RE: Peer Review Services – Park District Properties
City of Elmhurst Comprehensive Flooding Plan

Per request of the Elmhurst Park District, V3 has performed a peer review of the concept design and hydrologic and hydraulic modeling information provided to our office relating to the City of Elmhurst Comprehensive Flooding Plan (CFP). Our review focused on those parks your office indicated were potential sites for flood mitigation improvements. Included in that list of parks were Wild Meadows Trace (WMT), York Commons (YC), the eastern section of Golden Meadows (GM) and East End (EE) parks. V3 was able to obtain the hydrologic and hydraulic models which were used by the City of Elmhurst consultants to develop concept flood protection plans. Pursuant to our review, we offer the following.

Figure 5. Plan View of EE Site in the CFP NCalCritical Existing Model

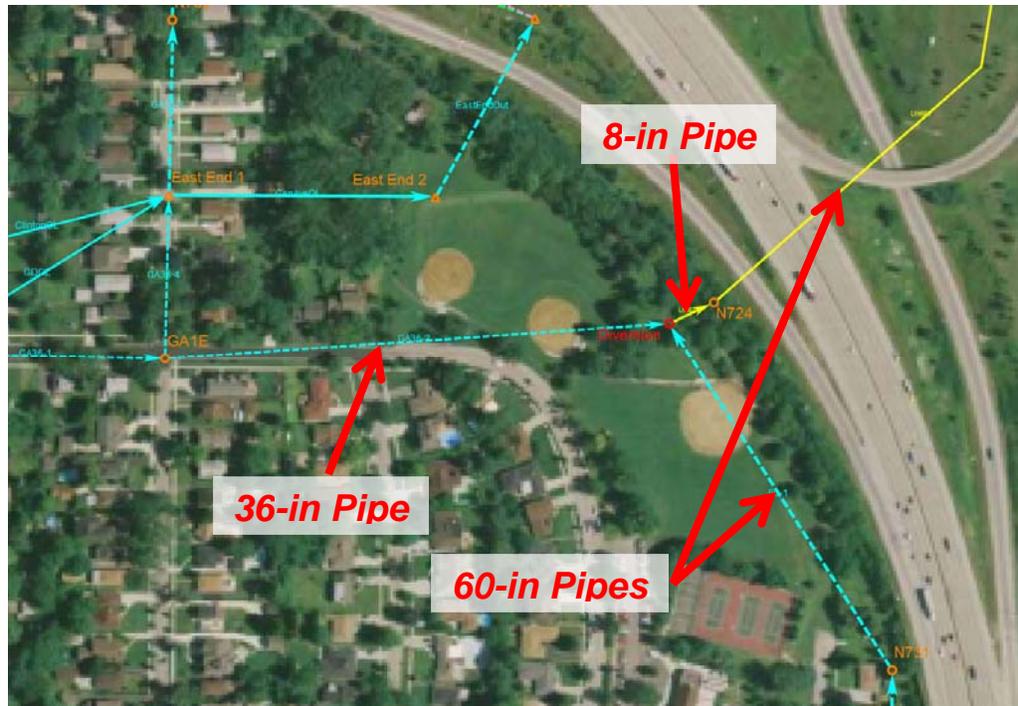
Observation 5: East End Park. The NCalCritical existing condition model describes a short 8-inch diameter pipe (Link673) downstream of the junction of a 36-inch sewer and a 60-inch sewer (60-1). The junction is labeled Diversion and the short 8-inch diameter pipe joins to a 60-inch pipe further downstream (Link665) at node N724 (see Figure 5 below).

Comment 5a: The presence of an 8-inch pipe restrictor in the system shown above may be the existing condition, but it seems unusual given the size of the incoming storm sewers, and should be confirmed. It seems that the presence of such a restricted condition would result in high elevations within the Geneva Avenue area and would exacerbate flooding conditions there and at EE. The fact that the calibration run gives higher elevations than reported by approximately one-foot might be due in part to this situation.

Comment 5b: There may be potential to work with the Illinois Tollway to remove the 8” restriction in this location and utilize the full capacity of the 60” storm sewer under the highway, without impacting downstream property owners.
